N1046A-02

Information Only Service Note

N1046A 100 GHz Electrical Remote Sampling Head Module

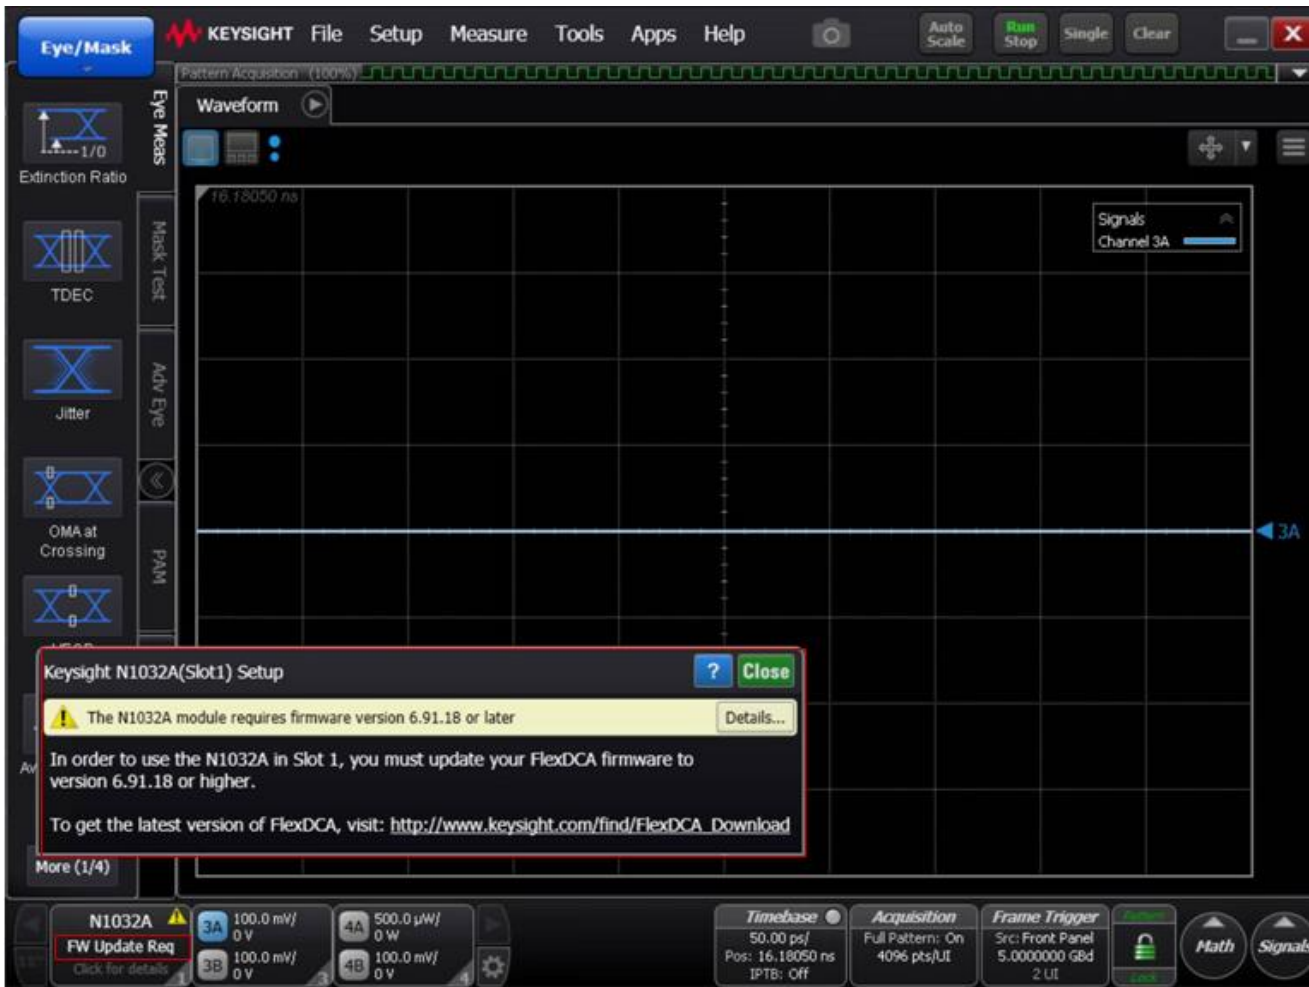
With the module installed in a DCA mainframe, if a message like the one below is displayed, FlexDCA must be updated to the indicated version (or later):

To update FlexDCA software, download from www.keysight.com/find/flexdca_download and install. While only the indicated version is required, updating to the latest version is recommended.
